REV.
D

AS5179™

RATIONALE

NUT, FITTING, PORT

FIGURE 1 - FITTING, NUT

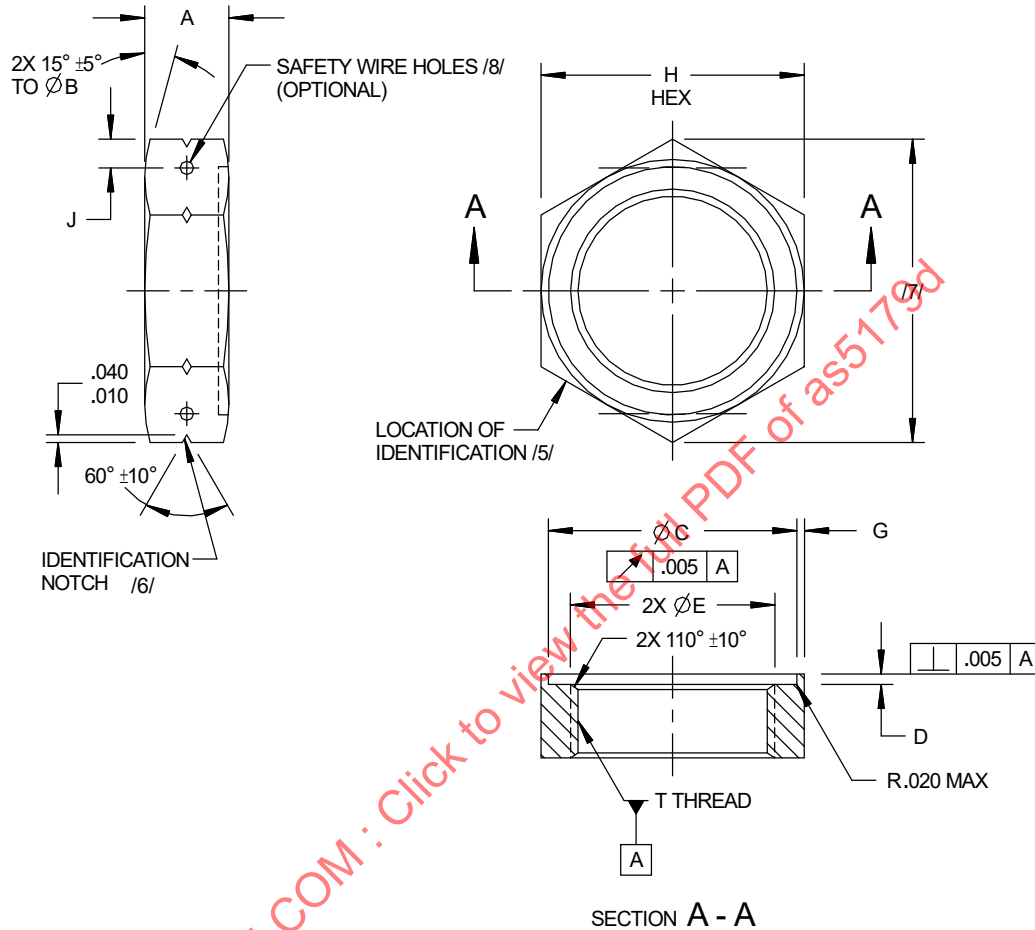
OPTIONAL MATERIAL SPECIFICATIONS ADDED TO 4130 AND 4140 MATERIALS. OPTIONAL ZINC-NICKEL FINISH PER MIL-PRF-32647 K16 ADDED. QML NOTE UPDATED TO CURRENT VERBIAGE. EXPLANATION OF IDENTIFICATION NOTCHES ADDED TO NOTE 6. NEW NOTES 17 AND 18 ADDED.

- a. DASH AS CODE LETTER: TYPE 4130 ALLOY STEEL BAR PER AMS6370 OR AMS-S-6758 OR TYPE 4140 PER AMS6349 OR AMS6382. /2/
- b. CODE LETTER D: TYPE 2024-T6 ALUMINUM ALLOY BAR PER AMS-QQ-A-225/6 OR TYPE 2024-T851 ALUMINUM ALLOY BAR PER AMS-QQ-A-225/6 OR AMS4339. /2/
- c. CODE LETTER J: TYPE 304 CORROSION RESISTANT STEEL BAR PER AMS-QQ-S-763 OR AMS5639.
- d. CODE LETTER K: TYPE 316 CORROSION RESISTANT STEEL BAR PER AMS-QQ-S-763 OR AMS5648.
- e. CODE LETTER R: TYPE 321 CORROSION RESISTANT STEEL BAR PER AMS-QQ-S-763 OR AMS5645.
- f. CODE LETTER T: TYPE 6AL-4V TITANIUM ALLOY BAR PER AMS4928.
- g. CODE LETTER W: TYPE 7075-T73 ALUMINUM ALLOY BAR PER AMS-QQ-A-225/9 OR TYPE 7075-T7351 ALUMINUM ALLOY BAR PER AMS4124. /2/

- (2) "-" CODE PARTS TO BE PLATED WITH ZINC-NICKEL PLATING PER MIL-PRF-32647, TYPE K16 ONLY, WILL HAVE THE FINISH CODE LETTER "U" AFTER THE SIZE CODE IN THE PART NUMBER.
